To: Menlo Park City Council

From: Gary Lauder

Re: Changing 101/Willow Rd. interchange from cloverleaf to partial cloverleaf

Date: Tuesday, February 23, 2016 [\[and updated subsequently as noted below\]](#)

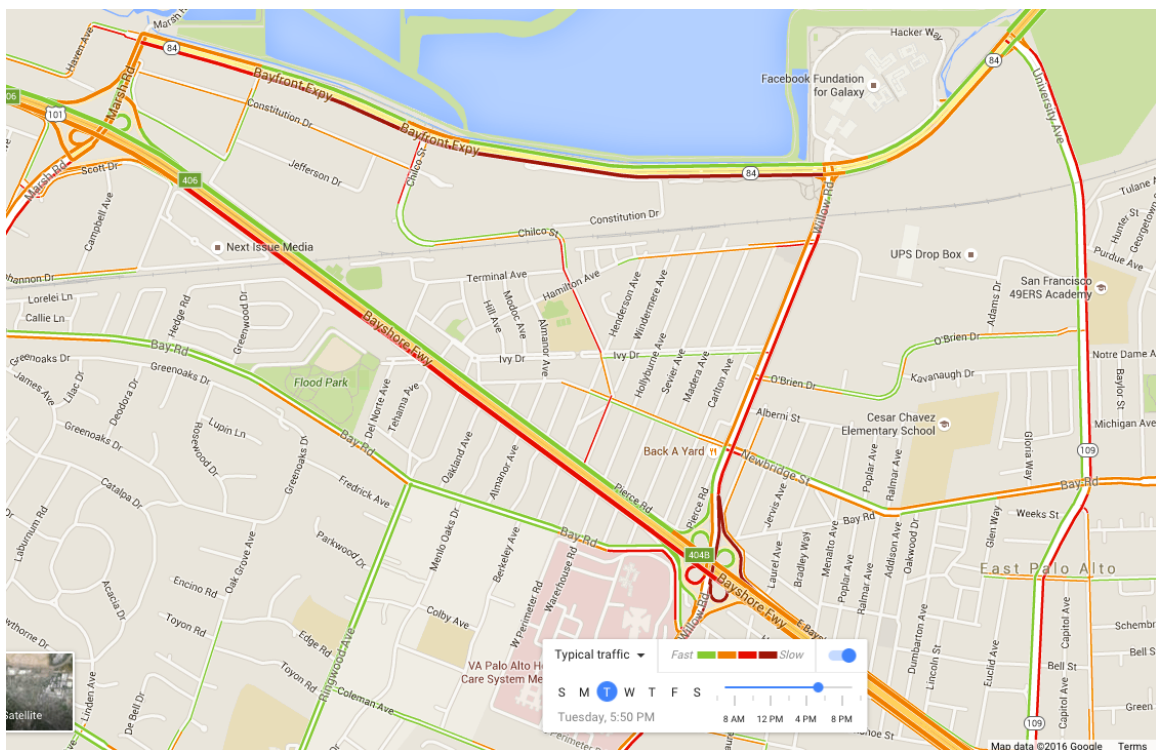
Page 14: "Northbound Route 101 off-ramp to eastbound Willow Road: Queues were observed to extend from the Newbridge intersection onto the off-ramp. The queue, however, was not observed to spill back to the freeway mainline."

At present, it spills back a full mile. The present traffic queue already exceeds the projections made for 2020. If the exiting traffic destined for westbound Willow were to be added to the existing queue, it would extend the queue beyond the University entrance ramp (and perhaps also the exit ramp). This would create a new hazard of crossover traffic, which has not been publicly evaluated.

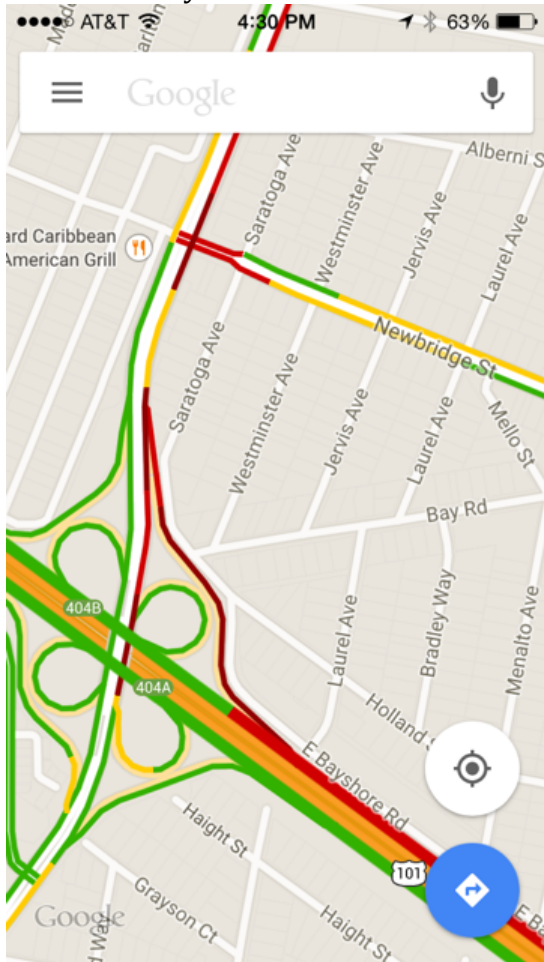
“The purpose of the project is to address the operational deficiencies of this interchange for all modes of travel and to reduce backups and upstream queuing on US 101. The need for this project is to reduce existing and expected traffic congestion in the vicinity of US 101 and Willow Road. **This congestion is being caused because of short weaving segments between loop ramps along US 101/Willow Road Interchange. These short weaving segments create weaving conflicts resulting in reduced traffic speed and increased upstream queuing and backups.**”

Anyone who drives this intersection knows that that is not the cause of congestion in this vicinity.

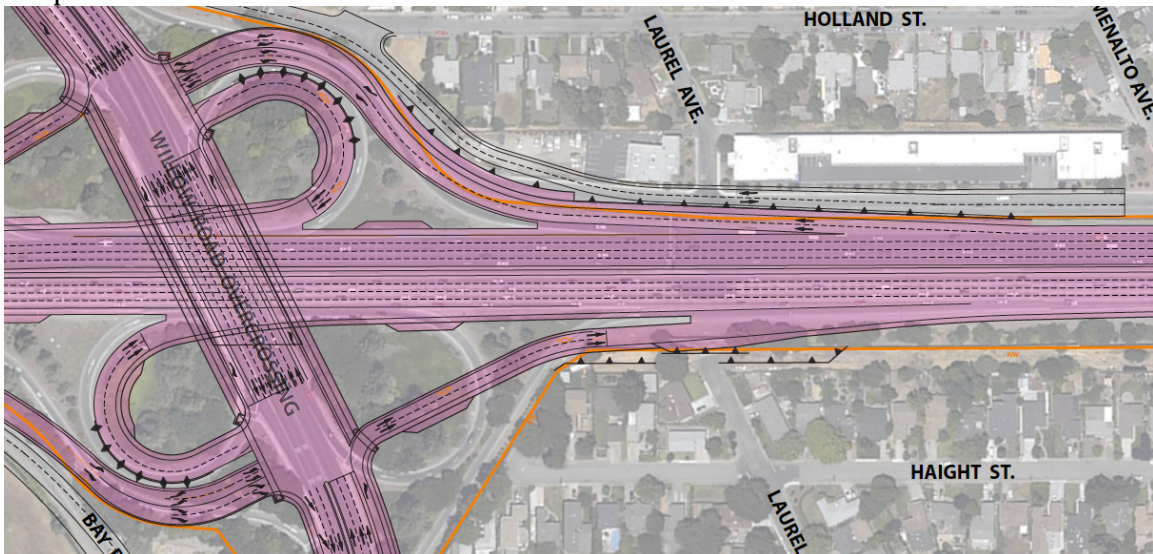
- 1) Drivers waiting at the traffic lights will be facing directly into the rising and setting sun on many days of the year.
- 2) When this was first planned, autonomous vehicles (self-driving cars) were not contemplated. Cloverleaves will be much better than parclo for maintaining speed without making passengers nauseous due to the larger turning radii of cloverleaves.

- 4) CalTrans claims that by having 2 right-turn lanes, it provides more "storage" for cars that are queuing that would reduce the backup to the highway. That might have been a valid claim back when the queue did not spill onto 101, but it's now a mile long. The planned incremental lane length looks to be <200', which is <4% of the maximum queue. The fact that officials still claim this shows that some form of delusion is occurring, either self-delusion or intentional. See close-up diagram extracted from larger diagram on next page:
